ADDENDUM NO. 1

DATE: January 27, 2016

SUBJECT: **Seguin Animal Shelter**

- **Revised Sheets C103; C106, IRR-1; ES-101; E-101; E-401**
- **Specification Section 32 31 13 – Chain Link Fence**
- **Revised CIQ form and form 1295**
- **Prebid sign in sheet**

# E-401

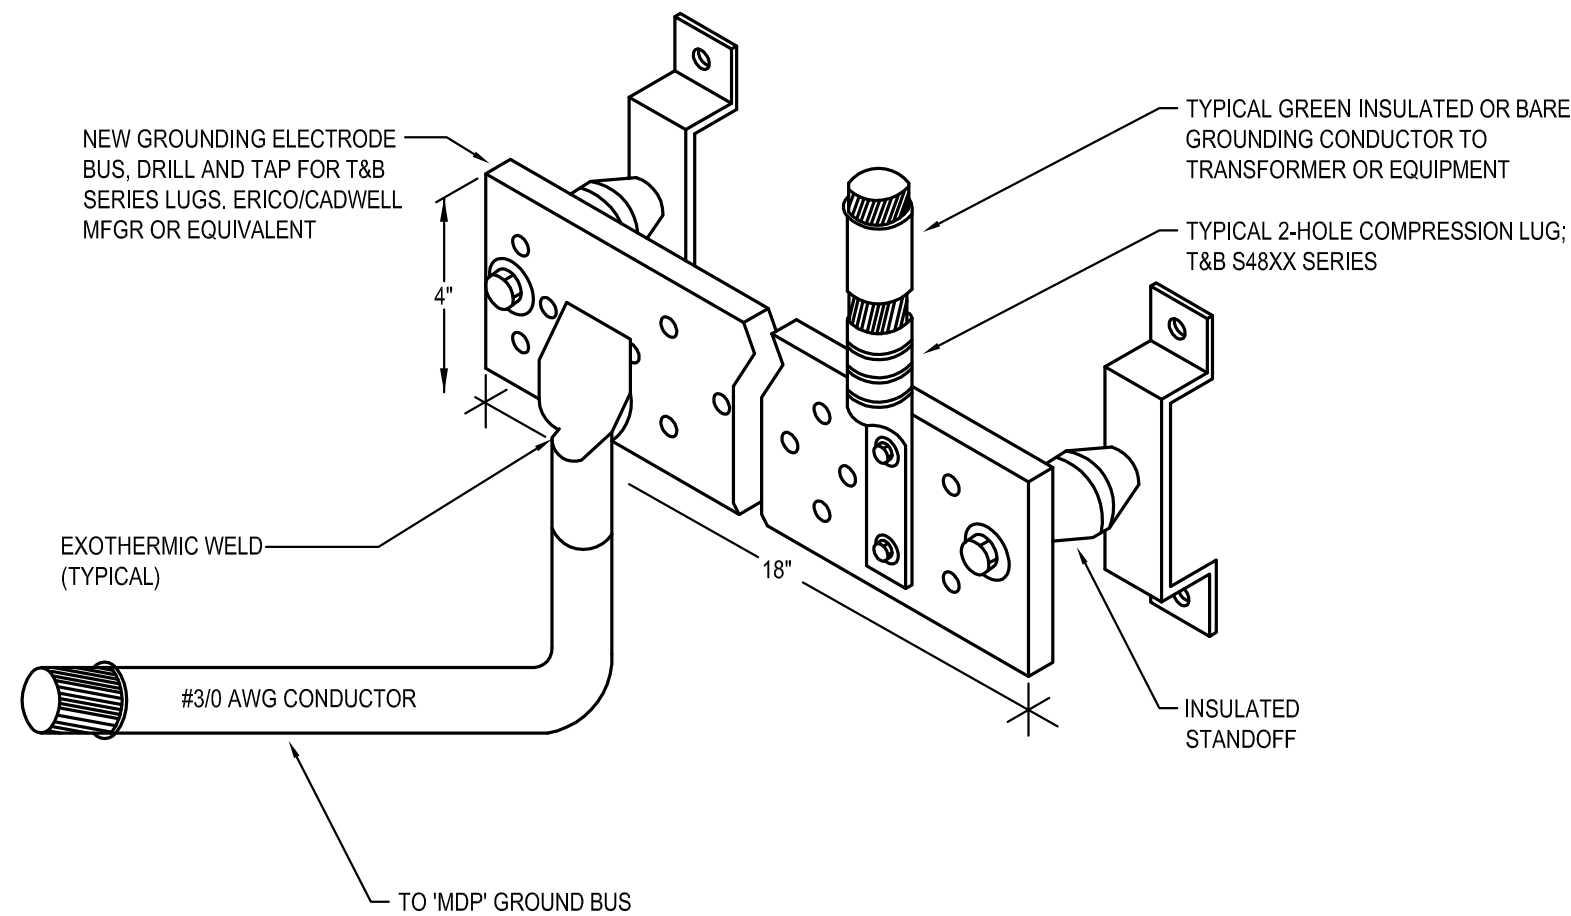
31. Refer to attached ES-101, E-101, and E-401 include modifications indicated, including classification for speaker conduit. Also reference Alternate #1, Canopy lights shall be equal to Metalux VT2 mounted to underside of structure.
